SUBJECT: Park Brake Air Fitting Replacement For Certain Chassis Mounted Sweepers

DATE: 1/22/2019

NUMBER: SB-0220

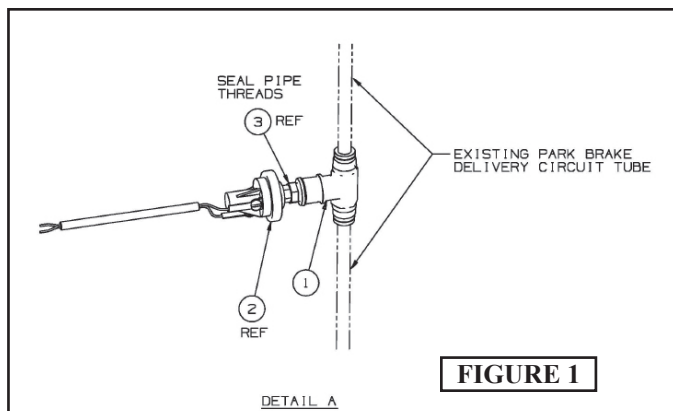
Starting October 2015, a non-DOT compliant "Tee Fitting" p/n 1121590 may have been installed in the park brake air line for Peterbilt, Freightliner, Navistar, and Autocar chassis. SB-0220 Campaign installation of FSO 1129889 to install the correct DOT compliant fitting is required on all affected units. FIGURE 1

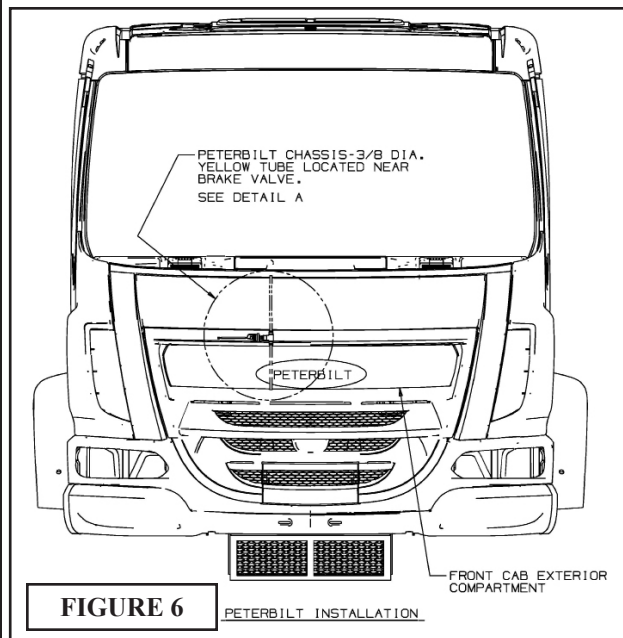
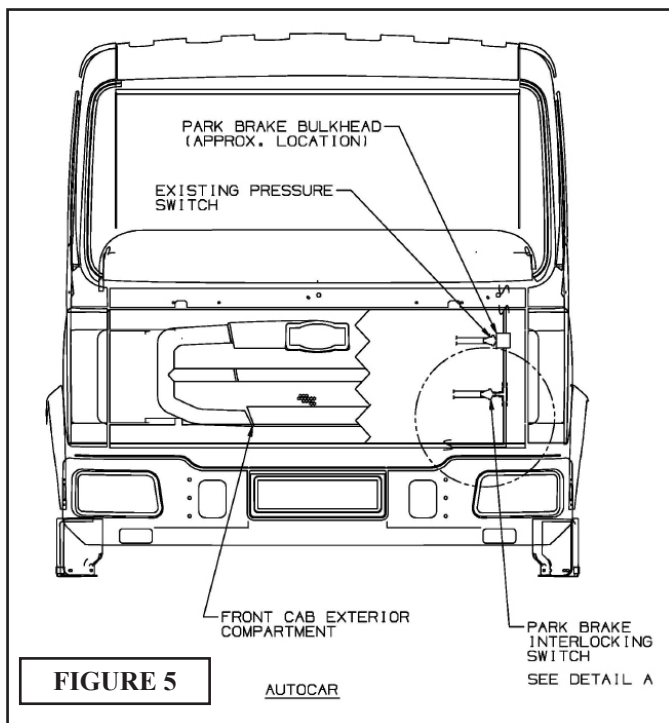
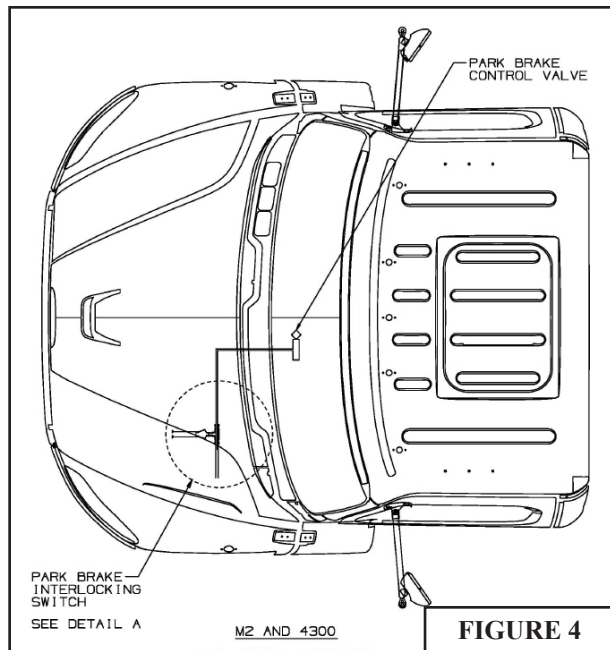
- INCORRECT DOT non-compliant fitting (1121590) is black composite. FIGURE 2
 - CORRECT DOT compliant fitting (1065665) has a brass body. FIGURE 3
3. If the composite Tee is found, Install the replacement FSO fitting as instructed in the drawing supplied with the FSO kit. See FIGURES 4-6 for chassis connector location.
 4. When installation is finished, complete the Audit/Test Instruction to ensure the correct hopper operation interlock function.

1. Order FSO 1129889 for each affected unit.
2. Inspect the Park Brake Switch Tee Fitting. See FIGURES 4-5-6 for the chassis location of the Park Brake Tee connection.
